Setting up of an Animal Rescue Centre at Barwe, Ranchi

XI **Biological Park, Itanagar**

(i) **Proposed enclosure for Slow loris, Jungle cat, Leopard cat, Civet, Marten, Owl and Porcupine**

**ENCLOSURE FOR SLOW LORIS , JUNGLE CAT, LEOPARD CAT , CIVETS,
MORTEN, OWL, PORCUPINE**

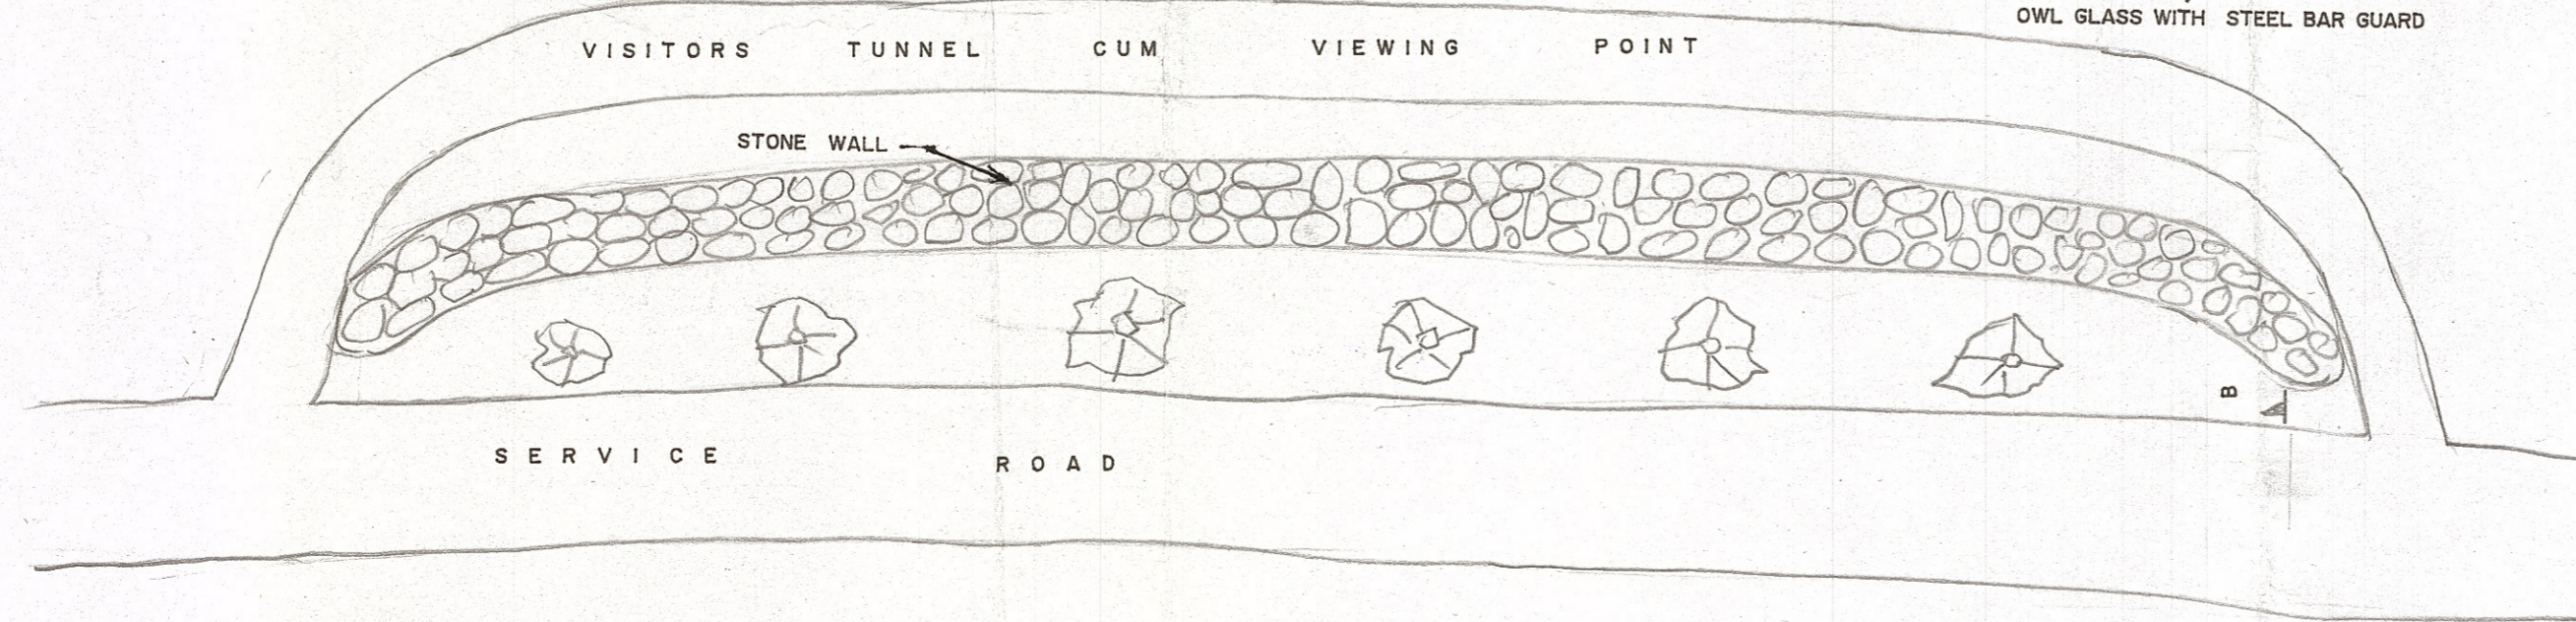
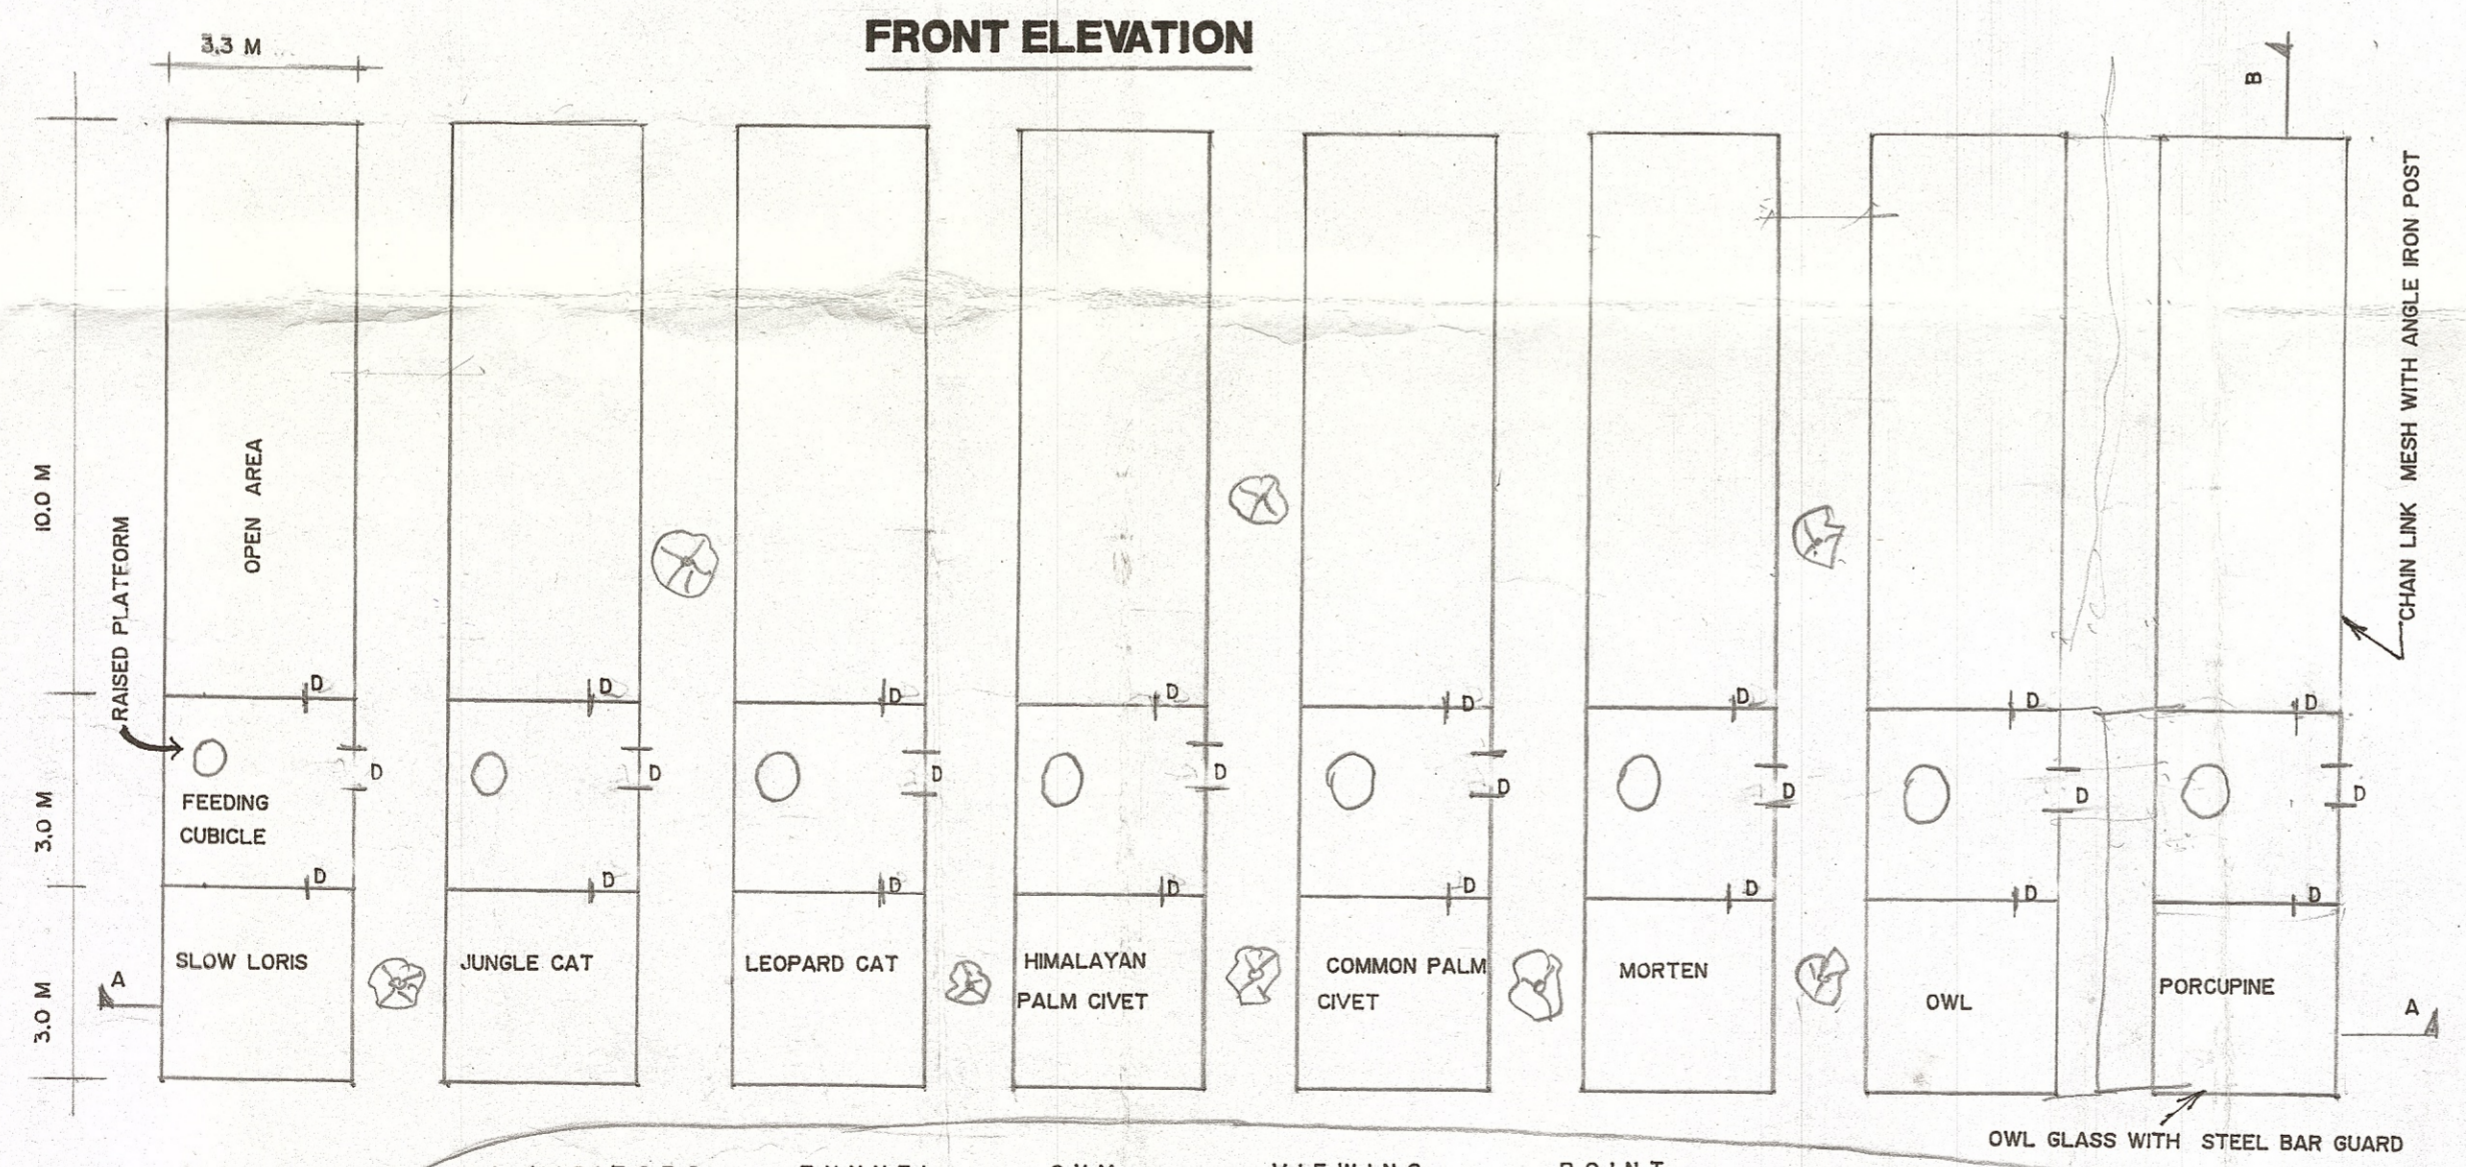
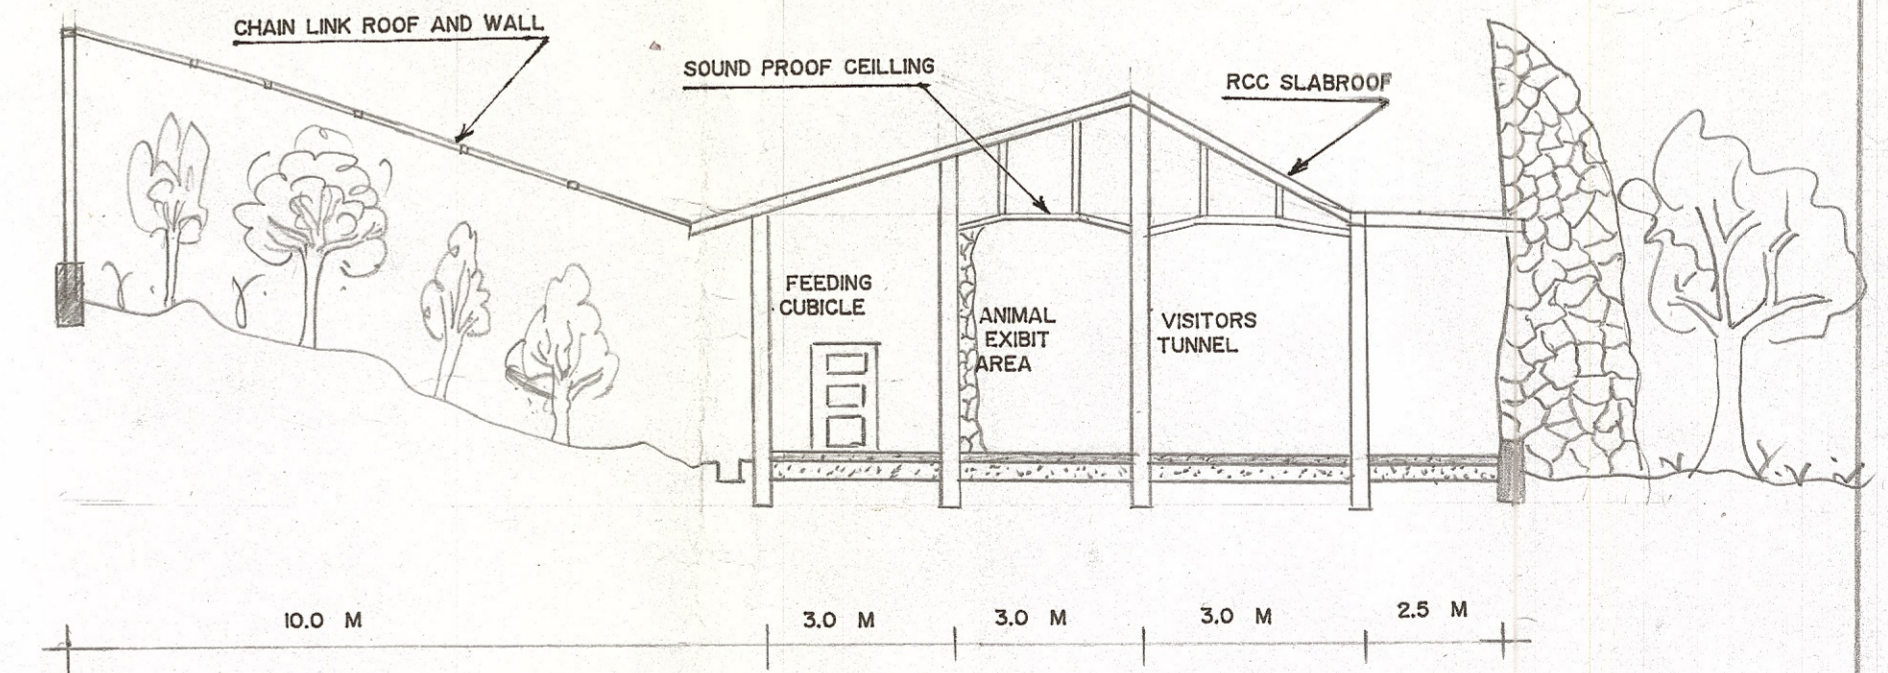
The design was scrutinized and approved subject to that the following modifications should be carried out:-

- (a) Each adjacent enclosure may be joined together with a passage between two set of enclosures each.
- (b) The paddock area may be separated with 2 feet space between two paddocks which shall be kept planted later.
- (c) Two adjacent enclosure can have connecting doors.
